# Delegated Report

## Householder Planning Application

**Planning Application No:** 20220634

**Description:** Erection of a two storey side extension and a creation of vehicle crossover

**Proposed Elevation**

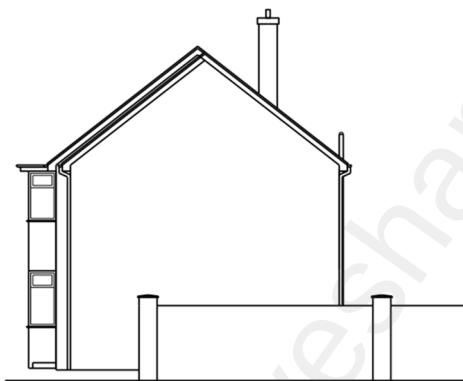
The proposed extension is to be set back from the front of the building by 0.35m and set down from the existing roof, with the roof form to be sympathetic to the existing. The extension is also set in more than 1.00m from the flank boundary which helps to maintain the existing rhythm of the street scene and allows a gap, characteristic of the area, to remain. However, the site is located on a prominent corner plot and the appearance from the return road must be considered. At the rear, the extension is not set down from the roof or set back from the rear wall and therefore the extension does not appear subservient from the rear vantage point.

The width of the proposed extension is 3.30m which is half the width of the existing dwelling, the height of the extension is 3.85m, the depth is 3.25m and the eaves are shown to be in line with the existing eaves of the main dwellinghouse. The end wall of the extension is to have no fenestration, and although this will have the benefit of being partially screened by the existing boundary wall and large shrub, the Design SPG (2021) indicates blank, uncharacteristic gables, or flank walls, will generally not be acceptable. It is noted the existing flank wall has some brick detailing to break up the render, as shown by the photo above.

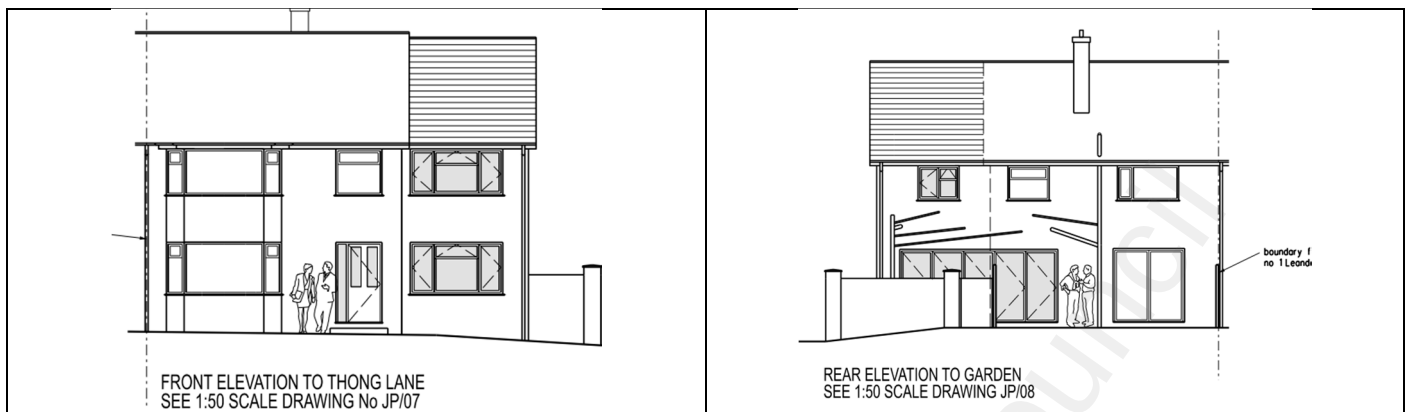
As indicated by the application form and plans, the proposed external walls are to be painted render, along with the rest of the existing property. The new roof is to have profiled concrete tiles to match the existing, windows are to be white UPVC, and doors white aluminium. In addition, the new timber panel fence will match the existing. Although the colour of the windows and doors would be acceptable, the window shape,

size and alignment do not match the original property exactly as shown by the proposed elevations below:

The Design SPG (2021) sets out the design expectations for development. As aforementioned in this report, the design of the extension along with the proposed external materials should generally match the existing dwellinghouse. As evidenced by the plans, the window frames do not match the shape of those of the existing dwelling. While it would be preferable for the windows to match exactly, they are not significantly differently. The existing windows are quite dated and it would not be unexpected for these to be replaced and upgraded in the future.

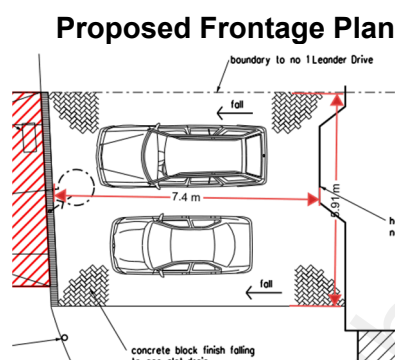
Due to the orientation of the plot, and the location of the proposed extension, the proposal would not have a detrimental impact on neighbouring privacy, outlook, loss of light or cause a sense of enclosure. The upper floor window on the rear elevation is to serve a bathroom and is shown on the plans as obscure glazed.
